# PERMIT

SEWAGE DISPOSAL SYSTEM

SUBDIVISION \_\_\_\_\_ ROAD 992 Henryton Road LOT Parcel 7

PROPERTY OWNER Robert Pickholtz

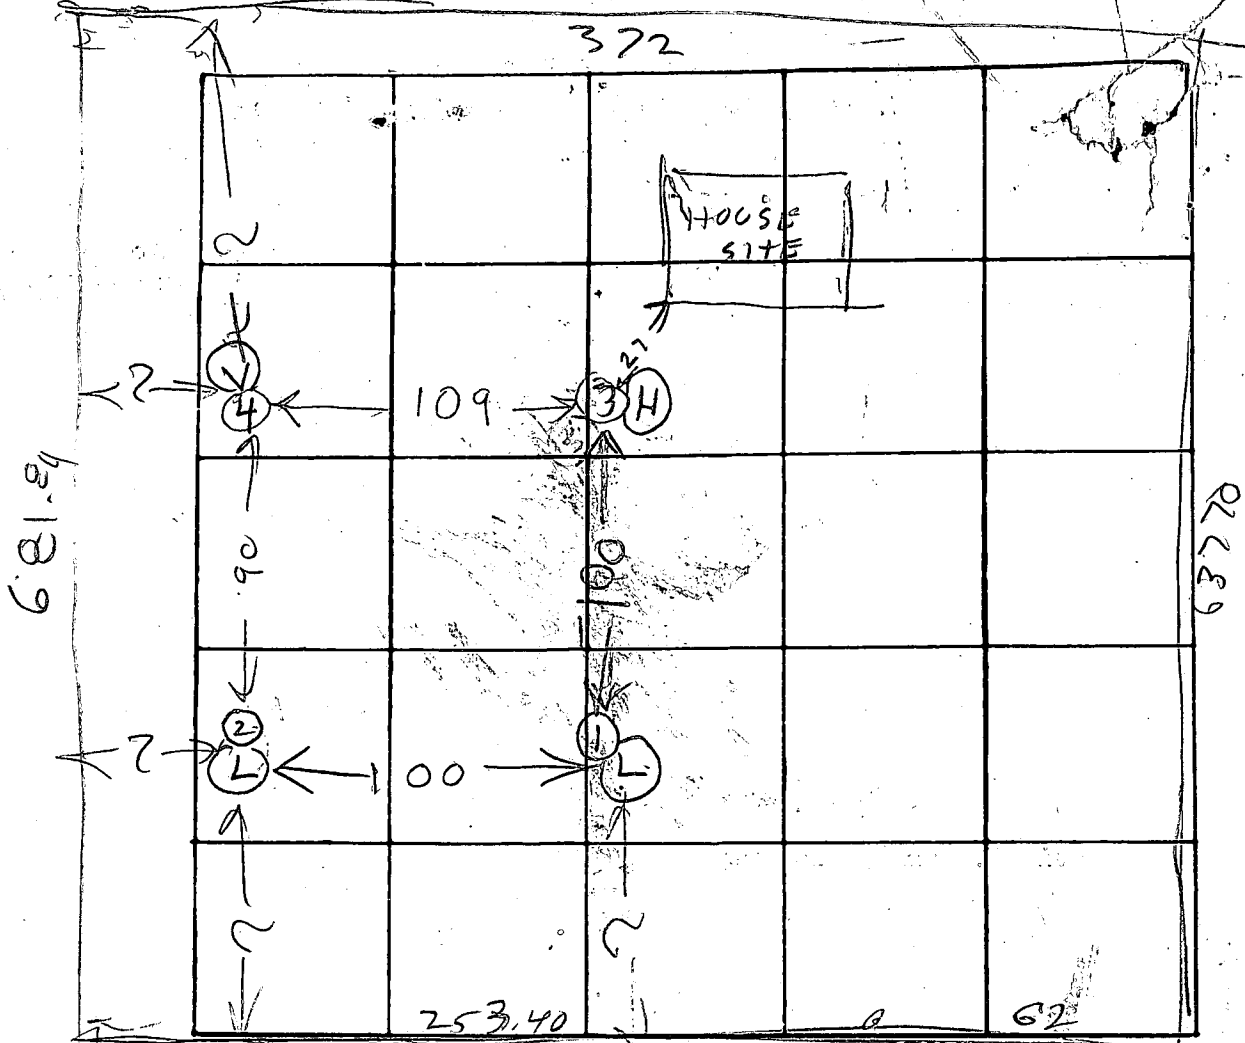
REASONS FOR REJECTION OR HOLDING 10/21/77 Perc OK Hold for  
plot with certified Holon RIT

REMARKS Certify Location of test Holes Not sure

PARCEL NO. 7  
PROPERTY OF  
DAVID A. CARNEY, ET AL.  
3<sup>RD</sup> ELECTION DISTRICT  
HOWARD COUNTY, MARYLAND  
MAY 19, 1978  
SCALE: 1" = 100'

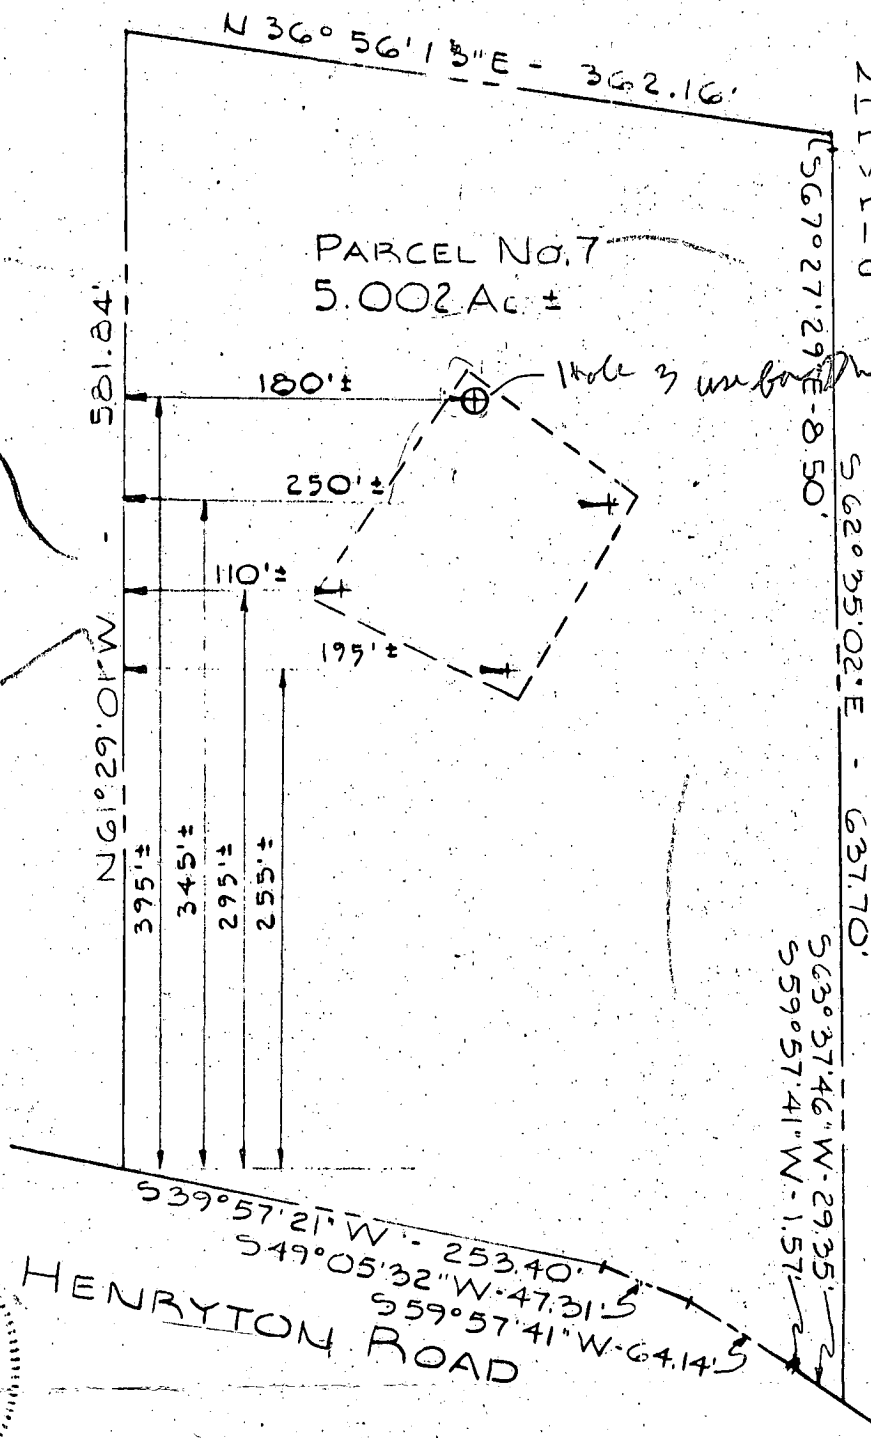
DRY WELL INLET TO BE MAX. ~~4~~<sup>3</sup> FEET BELOW ORIGINAL GRADE. *changed to 3F by RH 11/30/79*

PLACE THE DRY WELL ~~423~~<sup>395</sup> FEET FROM THE FRONT LOT LINE AND 180 FEET FROM THE  
**LEFT** LOT LINE AS SEEN WHEN FACING THE LOT FROM ROAD.
